STATE OF HAWAII DEPARTMENT OF TRANSPORTATION HIGHWAYS DIVISION
TYPICAL ROADWAY SECTIONS
INTERSTATE ROUTE H-3 F.A.I. PROJECT NO. I-H3-1(52)
SCALE: AS NOTED DATE: JULY 1988
SHEET No. H-1 OF 8 SHEETS

AS BUILT

STATE OF HAWAII
 DEPARTMENT OF TRANSPORTATION
 HIGHWAYS DIVISION
TYPICAL ROADWAY SECTIONS
 INTERSTATE ROUTE H-3
 F.A.I. PROJECT NO. I-H3-1(52)
 SCALE: AS NOTED DATE: JULY 1988
 SHEET NO. H 2 OF 8 SHEETS

TYPICAL SUPERELEVATION SECTION FOR HAIKU VALLEY BRIDGES
I.B. STA. 257 + 60 TO STA. 261 + 60 AND O.B. STA. 258 + 00 TO STA. 259 + 00
 Scale: 1" = 5' - 0"

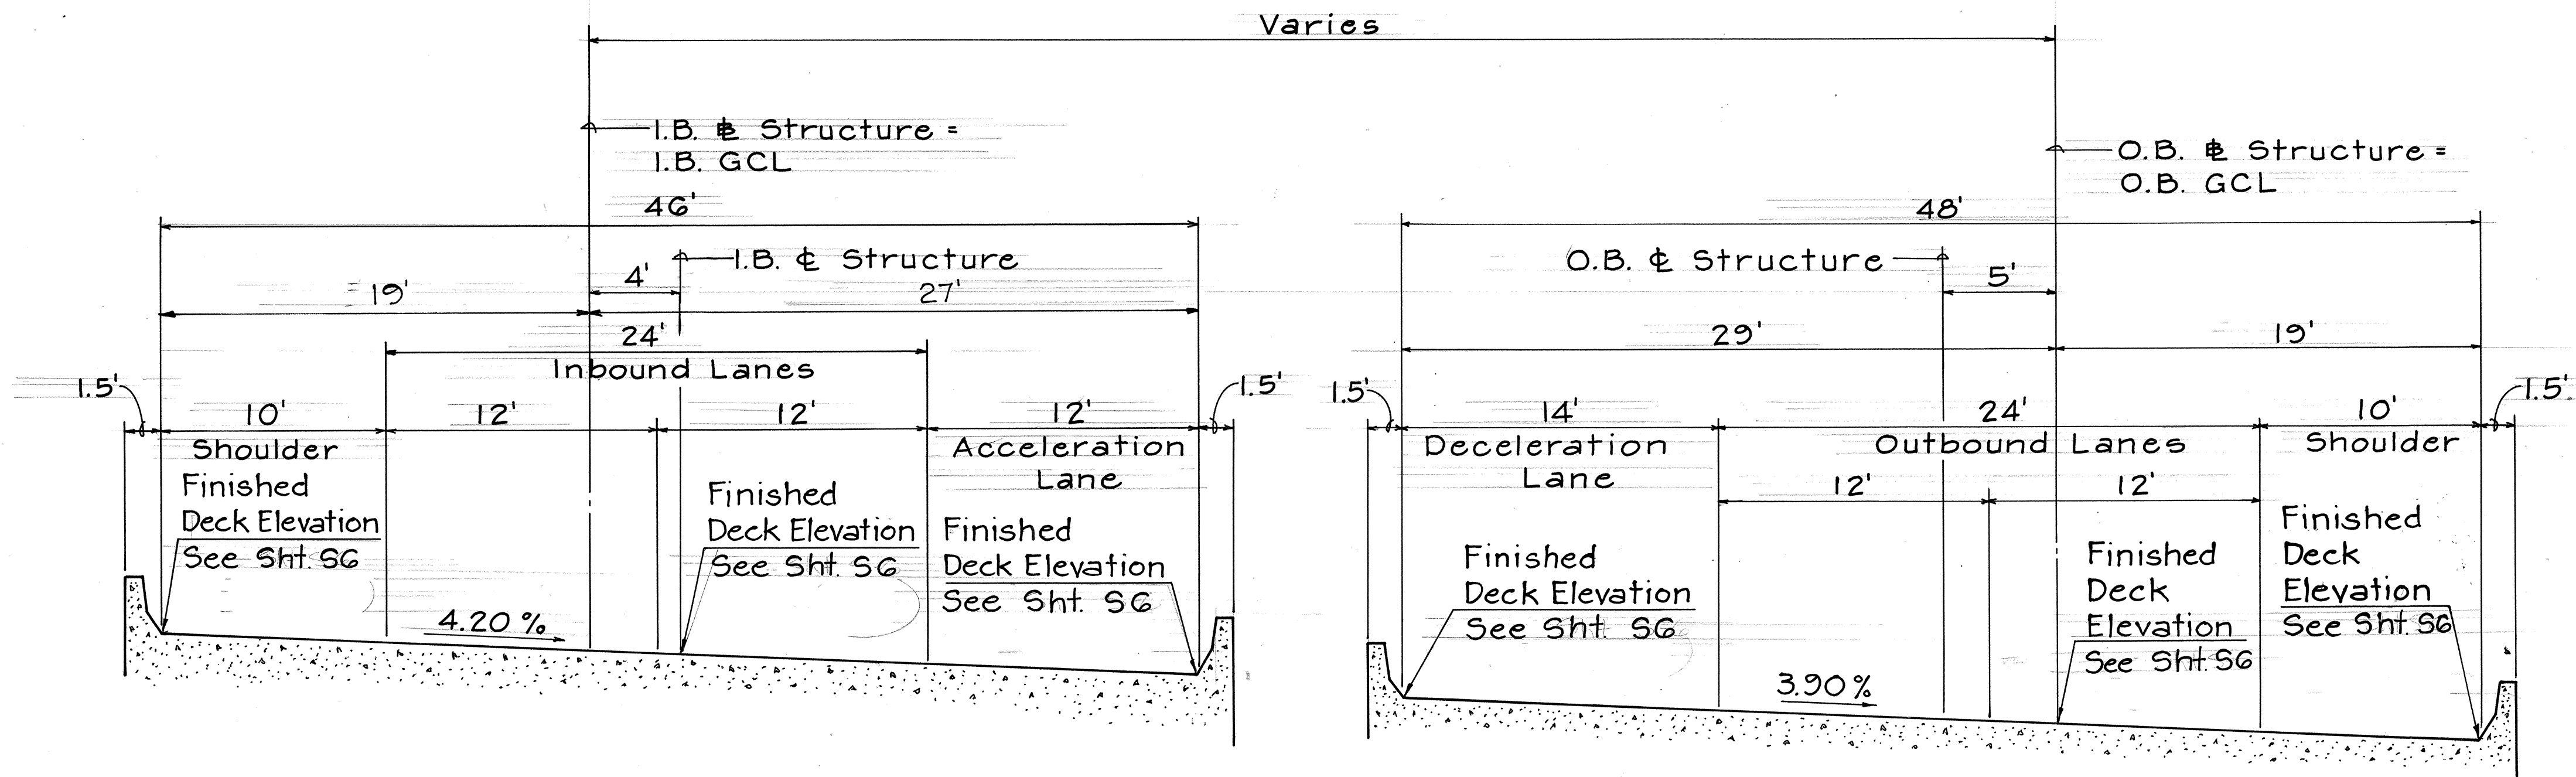
9/27/89	Revised Pavement Structure & Exist/Finish Ground
1/10/89	Revised Sta. 256+60 to 257+60 Typical Superelevation Section
DATE	REVISION

PAVEMENT STRUCTURE DETAIL
 SCALE: 1/2" = 1'-0"

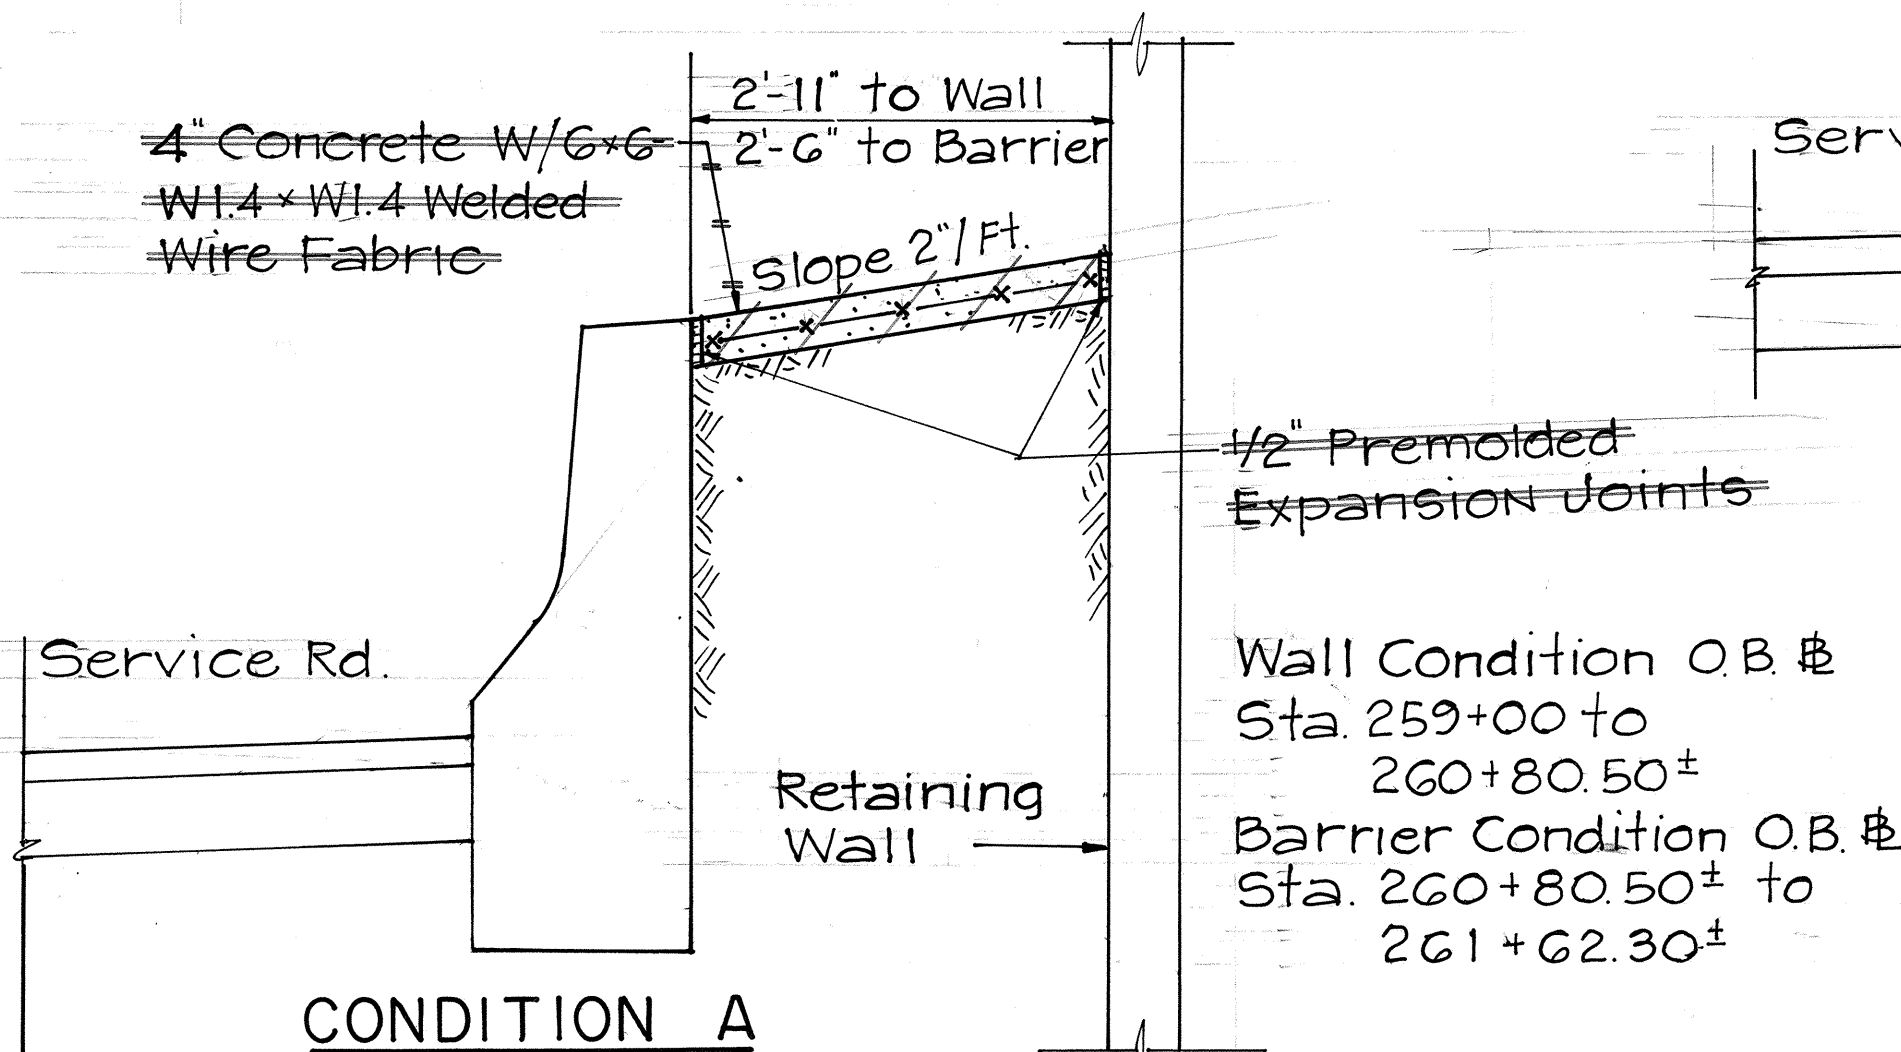
DATE	REVISION
9/27/89	Revised Pavement Structure and Exist./Finish Ground
1/10/89	Added Prime Coat, Premolded Expansion Joints & Dimension. Added Note "Omit Where Noted on Pavement Structure Detail"
